AGENDA
CITY OF CEDAR FALLS, IOWA
PLANNING AND ZONING COMMISSION MEETING
WEDNESDAY, MARCH 09, 2022
5:30 PM AT CEDAR FALLS COMMUNITY CENTER, 528 MAIN STREET

TO: Planning & Zoning Commission
FROM: Jaydevsinh Atodaria (JD), City Planner I
 Matthew Tolan, Civil Engineer II
DATE: March 3, 2022
SUBJECT: The Autumn Ridge Master Plan Amendment

TO: Planning & Zoning Commission
FROM: Jaydevsinh Atodaria (JD), City Planner I
 Matthew Tolan, Civil Engineer II
DATE: March 3, 2022
SUBJECT: The Autumn Ridge 9th and 11th Addition Preliminary Plat

TO: Planning and Zoning Commission
FROM: Jaydevsinh Atodaria (JD), City Planner I
 Luke Andreasen, PE, Principal Engineer
DATE: March 3, 2022
SUBJECT: RP District Site Plan for the Cove at Spruce Hills Townhomes (SP21-013)

Autumn Ridge 9th
and 11th addition
(proposed)

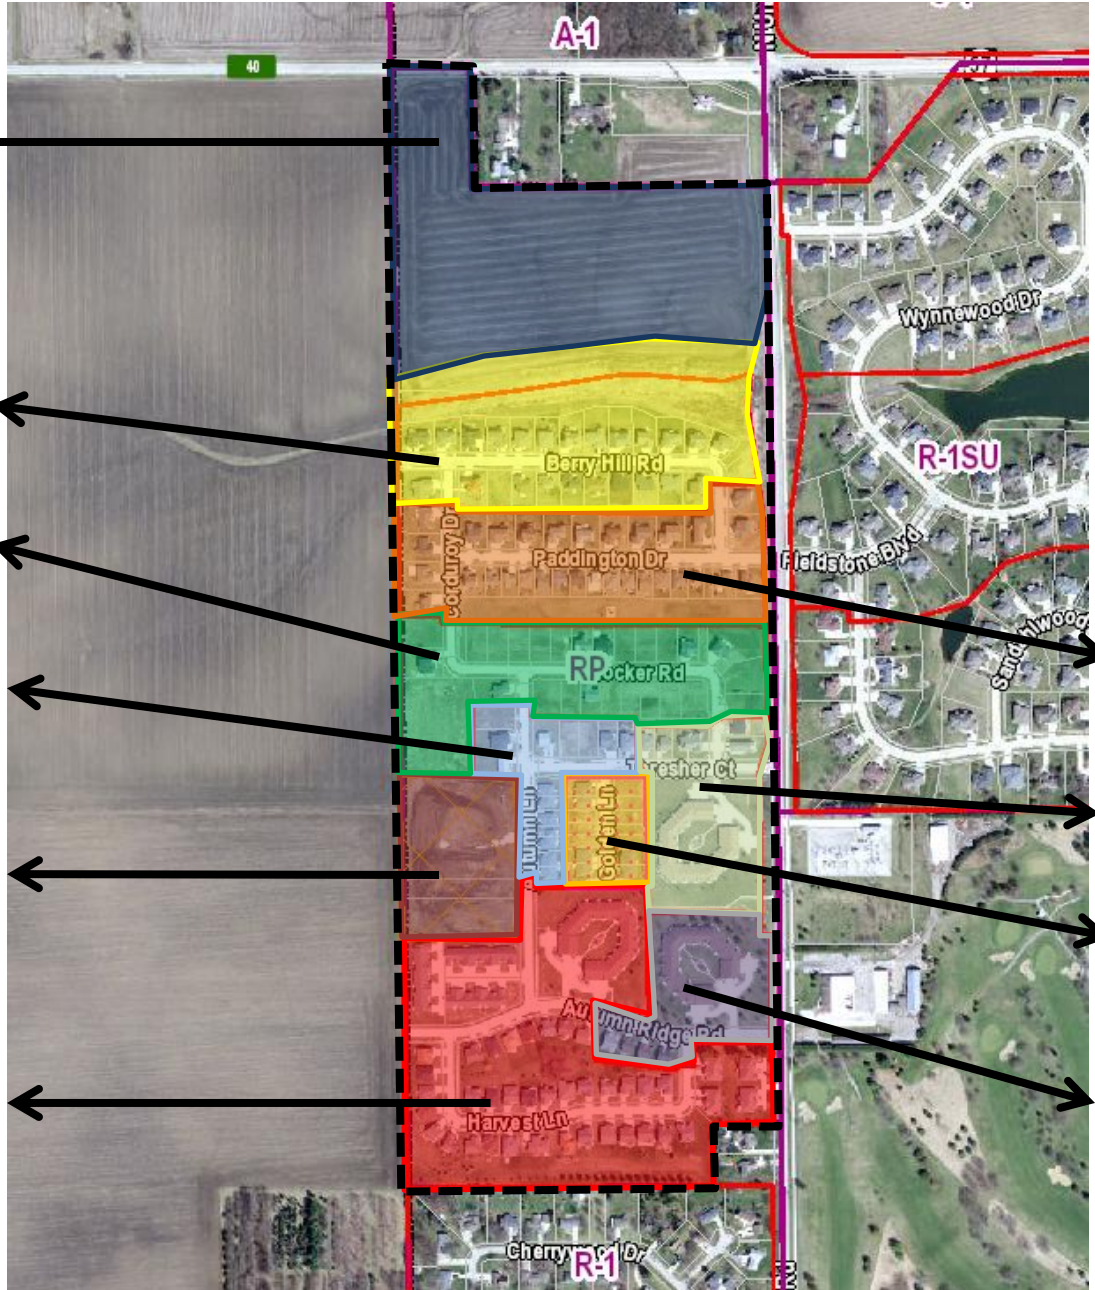
The Master Plan exhibit submitted with the current revised application highlights the two remaining phases (9th and 11th) in the subdivision in context with the rest of the development in Autumn Ridge. The updated RP master plan proposed by the developer is described below, with areas of change from the original plan highlighted and staff recommendations noted.

to the western boundary of the development to provide for future development to the west. The 9th and 11th Additions are planned to include 58 lots for single-unit bi-attached dwellings, 34 single-family lots and public park space. The area will be developed in two phases: Phase 1 will be Autumn Ridge 9th Addition, which will include 45 lots (19 single family units and 26 single-unit bi-attached dwellings); and Phase 2 will be Autumn Ridge 11th Addition, which will include 47 lots (15 single family units, 32 single-unit bi-attached dwellings and a little over one acre of public park space).

The developer is proposing to increase the number of bi-attached dwellings and reduce some of the lot sizes for the single family units in the proposed Autumn Ridge 9th and 11th Addition in response to market demand. The City supports the idea of additional density and a variety of housing types to serve the needs of the community. The proposed master plan shows that the single family units are proposed along the perimeter of the development including the lots abutting Union Road, W. 1st Street and along the western boundary of the development. The bi-attached units are proposed in the central section of the proposed 9th and 11th Additions.

Staff is supportive of the increased residential density. Providing a variety of housing types and sizes provide opportunities for people of all incomes and age groups to live in the community. For example, first time homebuyers, empty nesters, and retirees may find attached dwellings to be an attractive and affordable option to meet their needs. However, as currently proposed, all of the bi-attached units will have street-facing garages. This will result in an excessive number of driveway curb cuts (see attached driveway exhibit). With this many curb cuts, there will be little room for on-street parking, sidewalk continuity will be compromised and front yards will be largely paved. City Staff made a number of suggestions to the developer that could help alleviate this concern. The developer has indicated that they would like to move forward with the proposal with the street-facing garages, but to address the issue is proposing to add a clause in the developmental procedures agreement and deed of dedication stating that all lots equal to or less than 60 feet in width will be limited to maximum driveway width of 18 feet at the curb-line.

While staff is not opposed to the elimination of the wet-bottomed retention stormwater basin (lake), elimination of the shared open space and amenities entirely is not recommended. In response, developer has included Outlot 1 in the proposed master plan, which is labeled as “Green Space or Park Space.” The green space is proposed to be included in the second phase of development. This green space will need to be carefully graded and seeded to provide usable park space (more details about the proposed park space are included in the preliminary plat staff report). Staff also notes that the developer proposes a sidewalk connection to access the park space from the Union Road sidewalk, to provide easy accessibility to park space for all residents of Autumn Ridge, both north and south of the drainage way. This sidewalk connection will require the developer to collect and convey the previously established Union Road drainage ditch into a storm sewer pipe that will release southerly adjacent to the Union Road culvert structure. Additional grading will be done to tie the southerly limit of the park space into the existing stormwater detention facility.

PRELIMINARY PLAT AUTUMN RIDGE NINTH AND ELEVENTH ADDITIONS CEDAR FALLS, IOWA

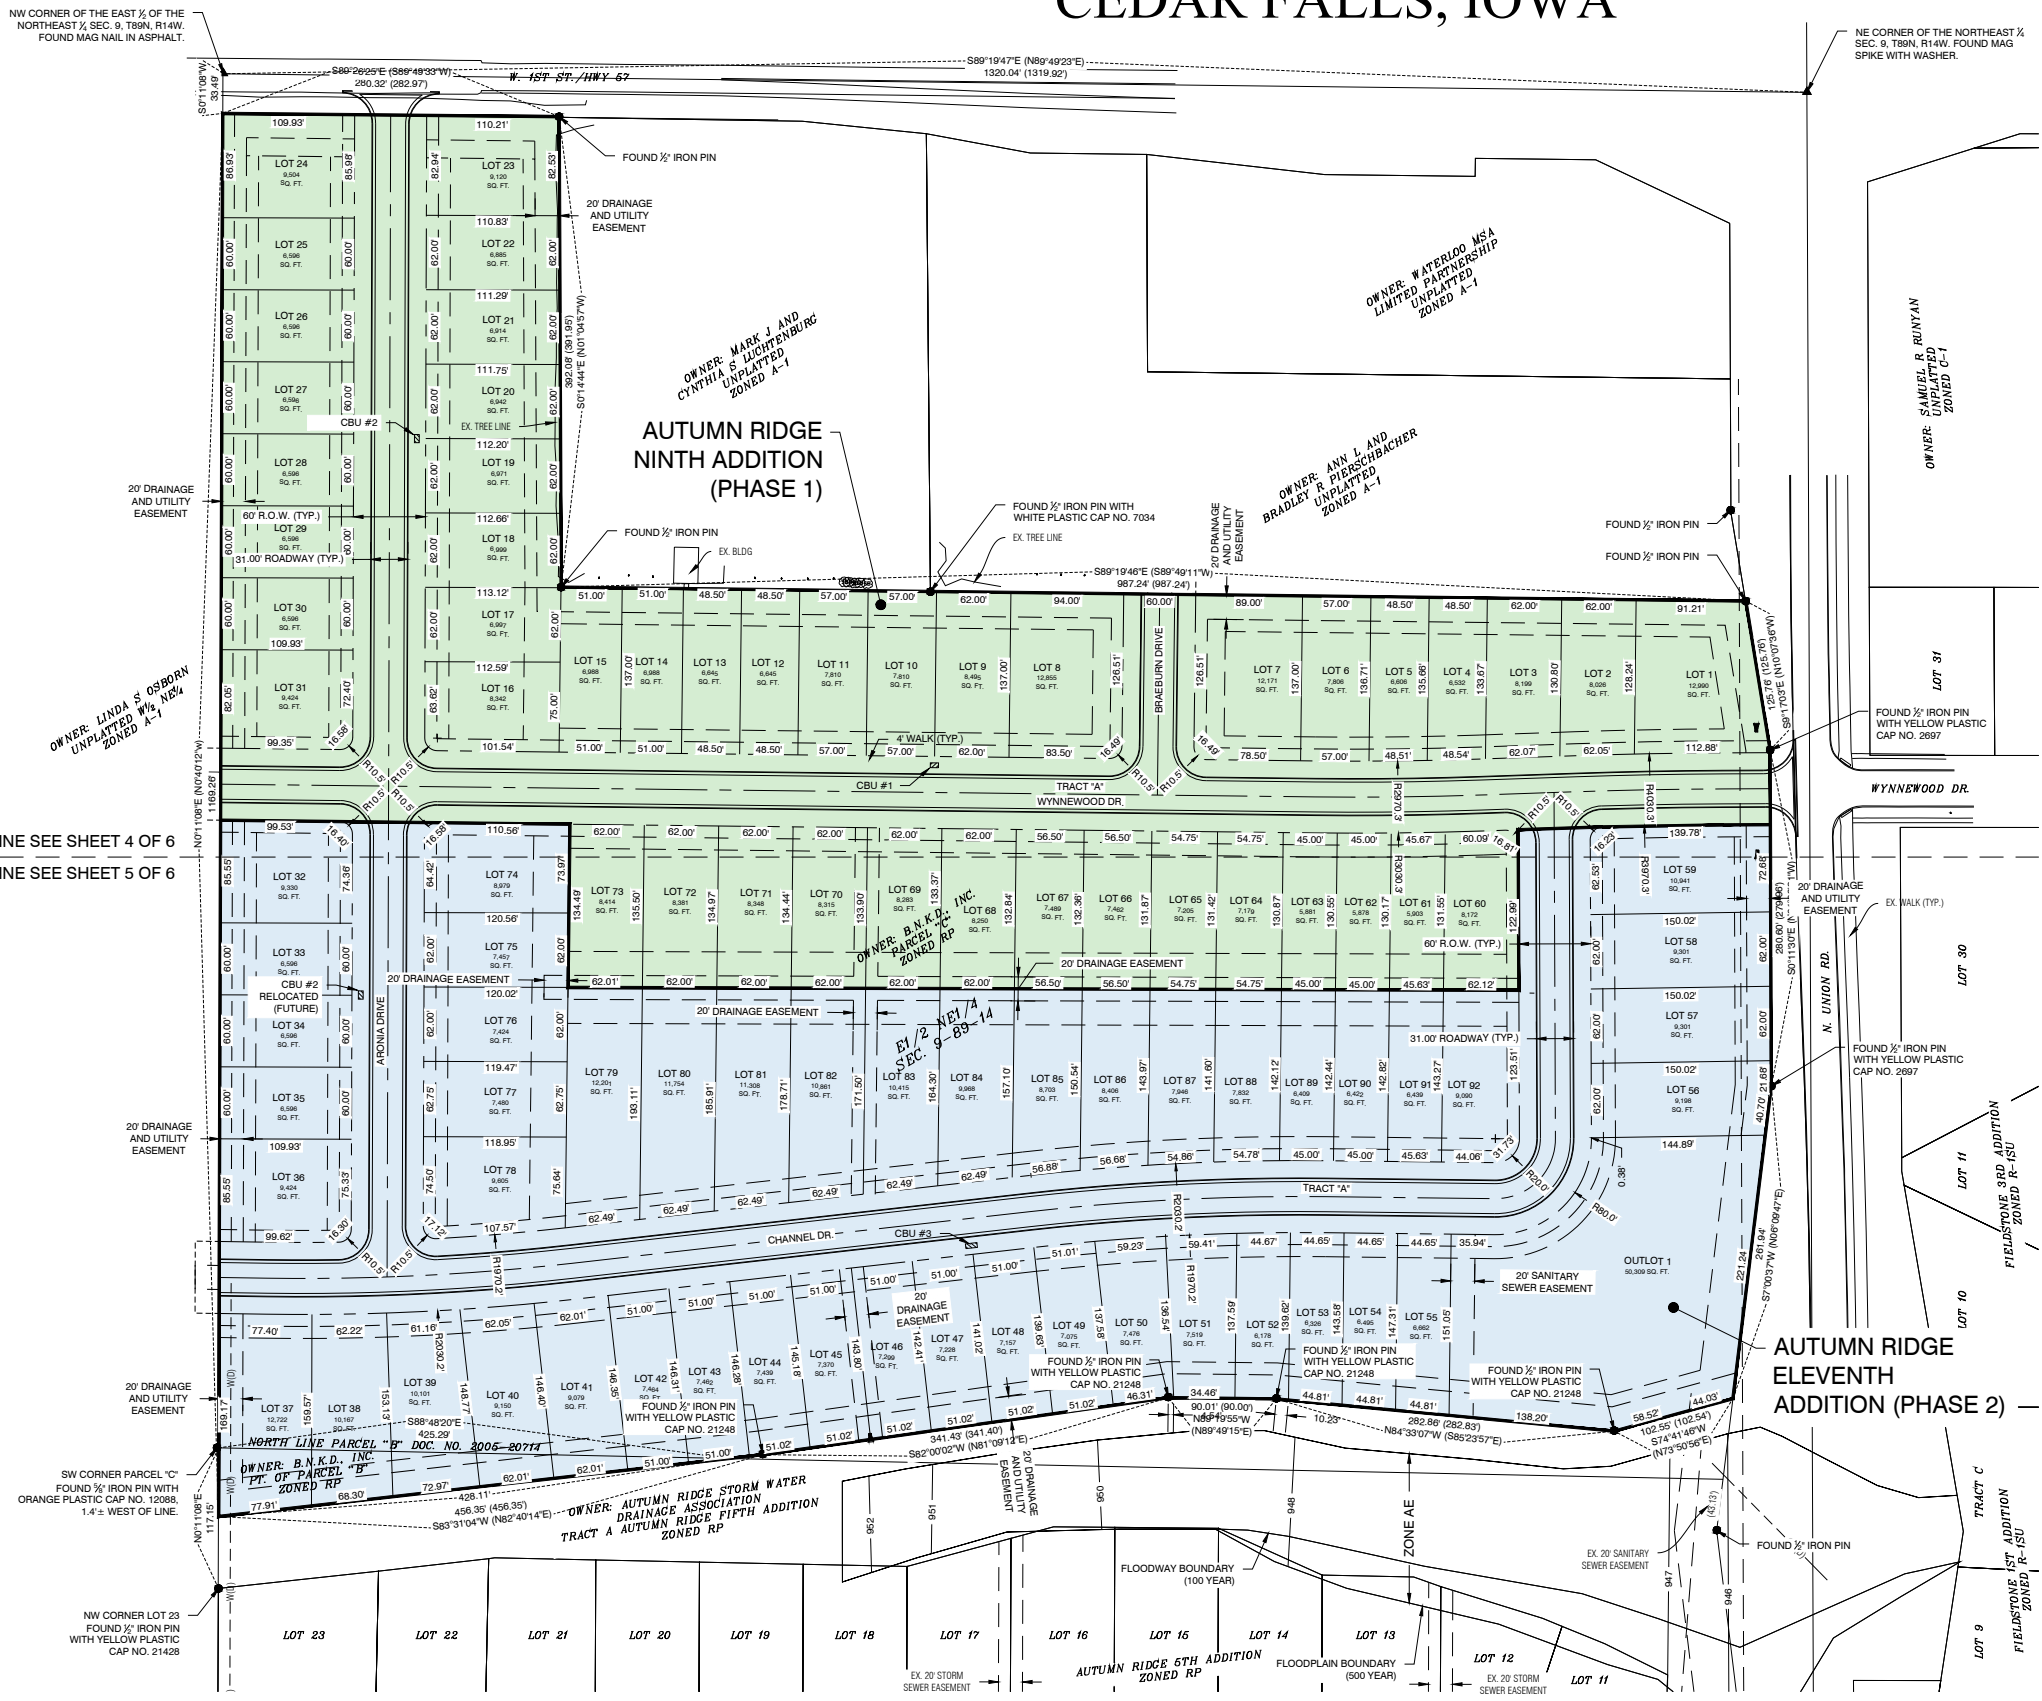
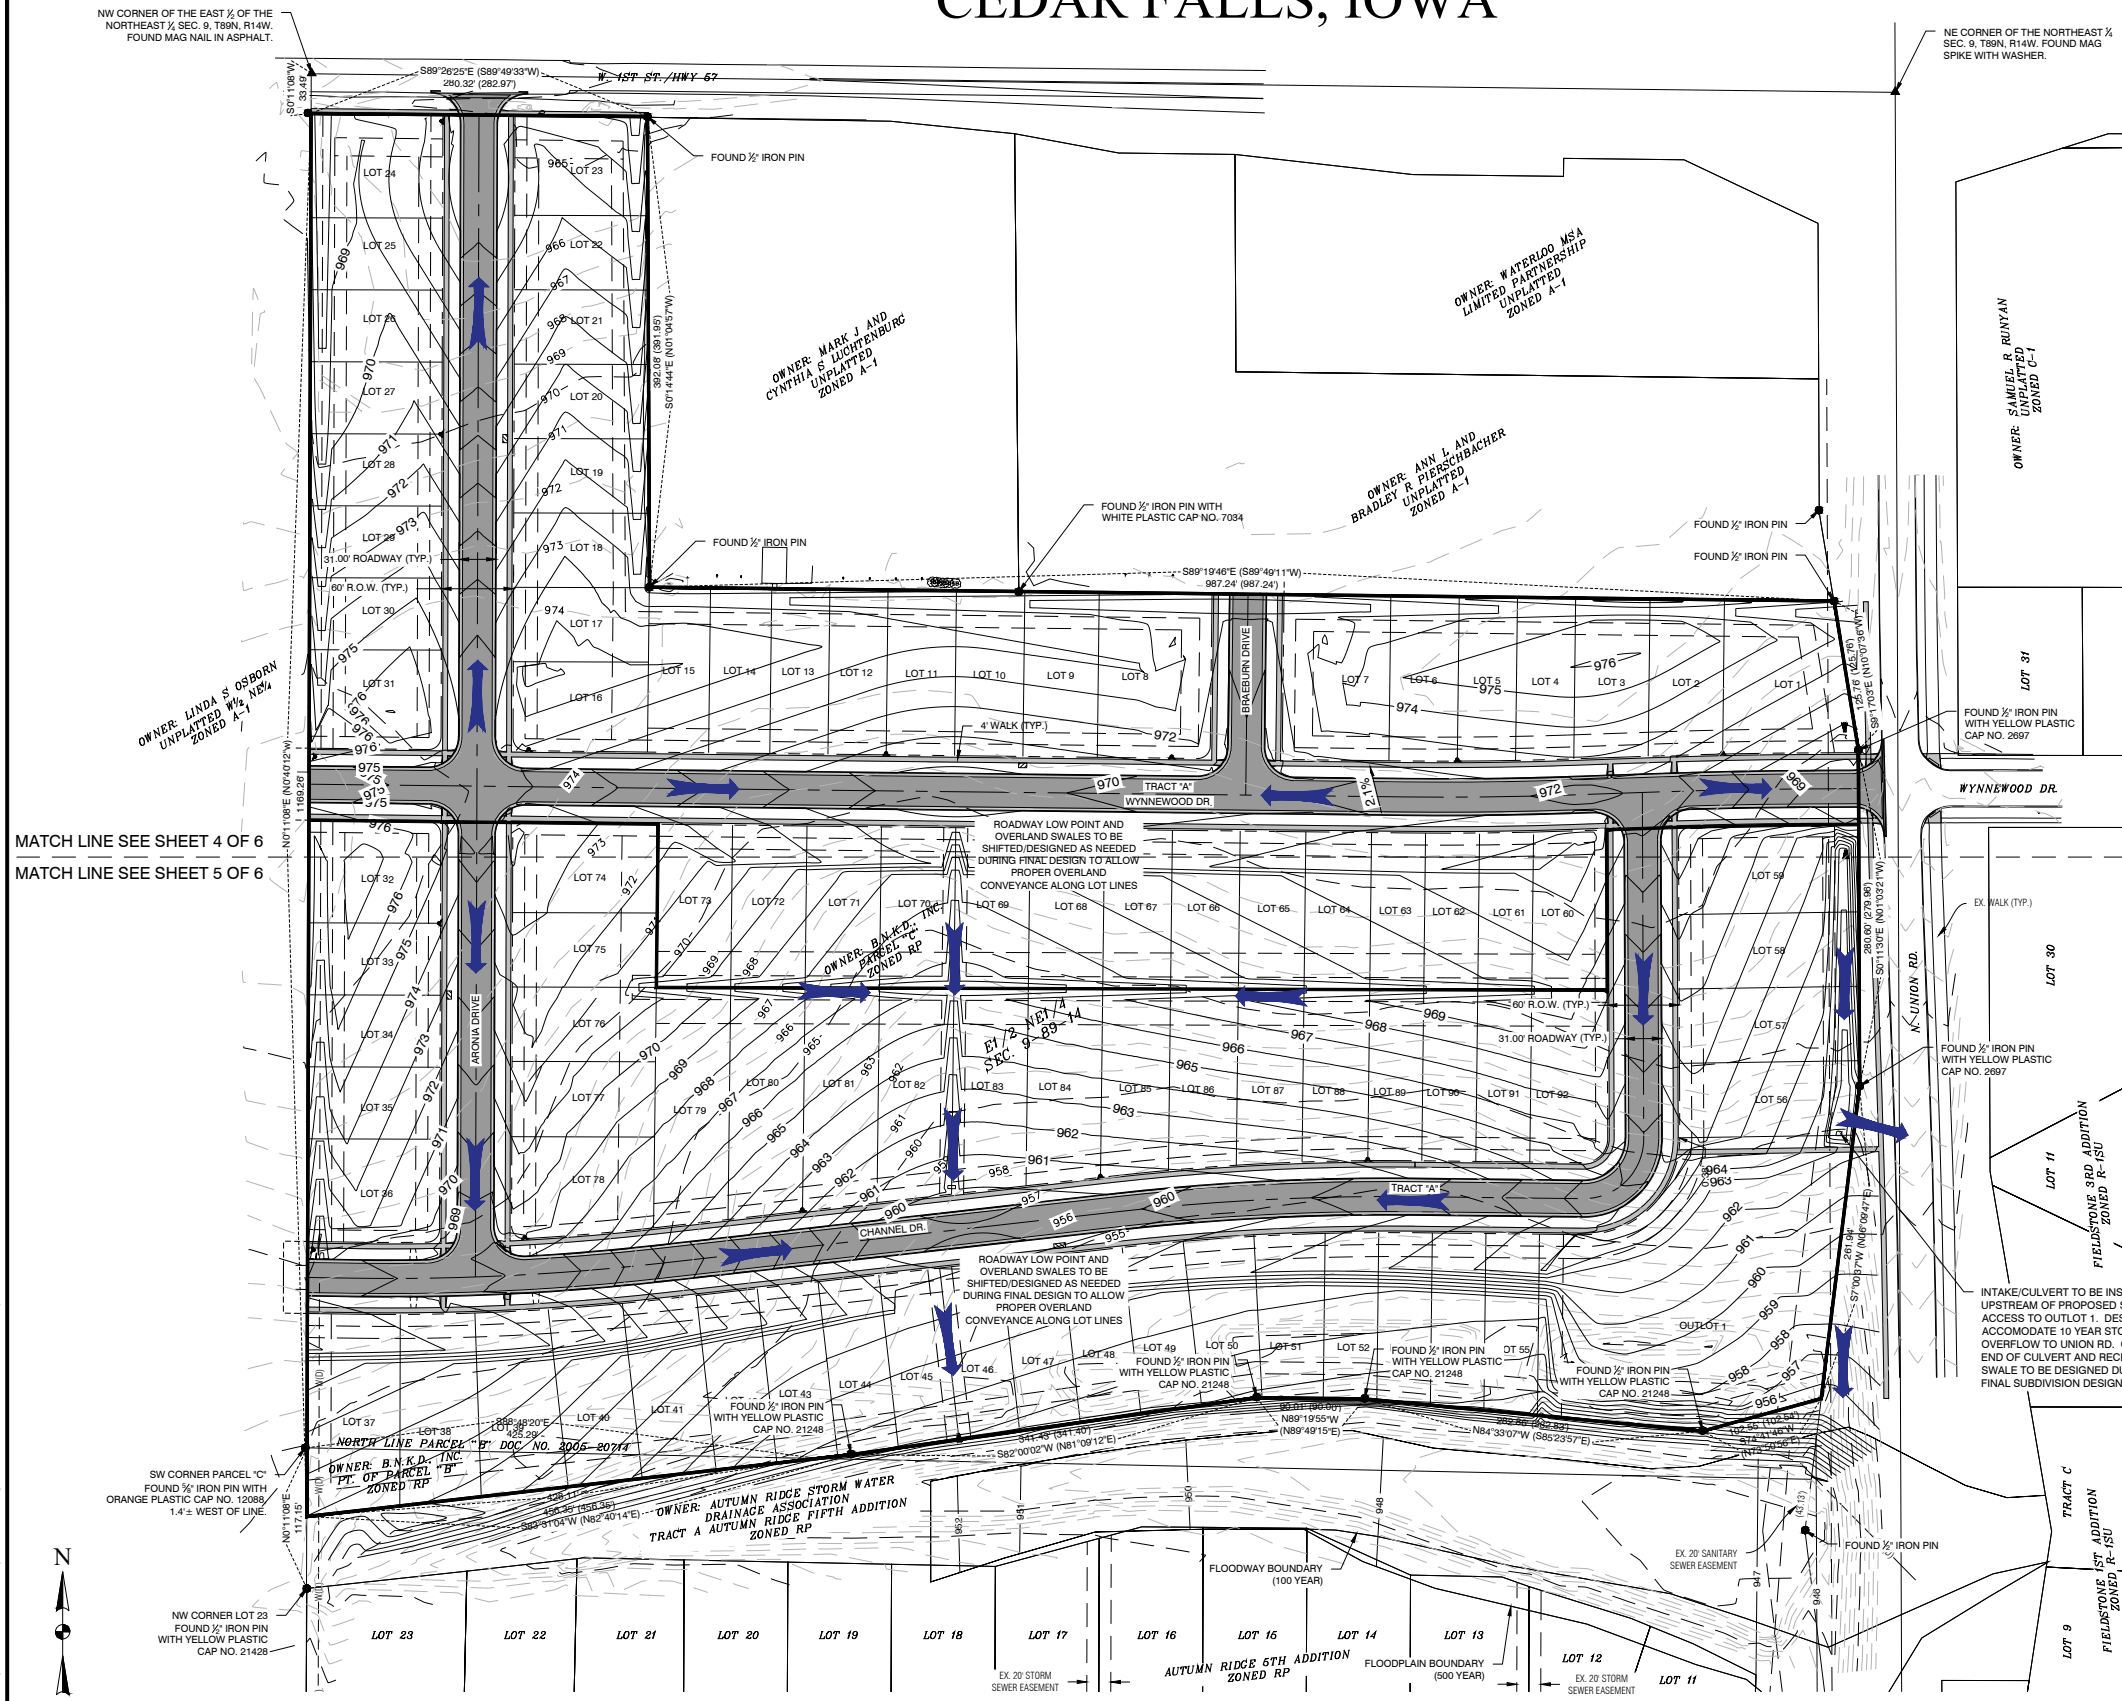
Proposed single-unit bi-attached dwelling lot size varies from 5,878 sq.ft to 12,855 sq.ft in area, so meets the requirements of the RP District. City staff notes that the developer has provided two examples of type of unit that they will be implementing (see below), In general, for the narrower lots intended for bi-attached units, the designs will need to be carefully planned to ensure that minimum side setback requirements can be met.

City staff notes that the duplex units are all proposed with front-loaded garages. As described in the staff report for the RP Master Plan amendment, staff is concerned about the effect that so many driveways and curb cuts will have on the livability of the neighborhood, as there will be little room for on-street parking, street trees, or landscaped front yards. Driveway paving will cover a significant portion of the front yards and interrupt the sidewalk along the street.

The developer has indicated that they would like to move forward with the proposal and to address the issue of wider driveways and curb cuts, developer is proposing to add clause in the deed of dedication stating that all approaches and driveway in the development be no more than 18 feet wide at the front lot line. For lots with 3-car garages, driveways may then be flared out in a manner that meets the zoning code standards, so there is separation between the public sidewalk and any extended area beyond the 18 foot width. While staff is still concerned about this issue and the quality of the neighborhood streetscape it will produce, we are accepting of this solution.

To provide for pedestrian circulation public sidewalks are required along the west side of Union Road bordering the eastern boundary of subdivision and south side of W 1st Street bordering the northern boundary of subdivision. These sidewalks must be installed with the 9th Addition. Public sidewalks, minimum 4-feet in width, must also be constructed along all internal streets within the subdivision to provide for pedestrian circulation. A mid-block sidewalk connection will be constructed in the second phase of development (11th Addition) between the Union Road sidewalk and Channel Drive to provide easy access for residents in the southern part of Autumn Ridge to the park that will be developed in the 11th Addition.

In the November 2020 staff report, staff recommended amending the preliminary plat to include a minimum of 2 acres of shared open space to meet the subdivision code requirement for open space and to comply with the spirit of the originally adopted RP Master Plan and developmental procedures agreement, as described in more detail in the staff report for the proposed amendment to the RP Master Plan. In response, developer has included Outlot 1 (1.15 acres),
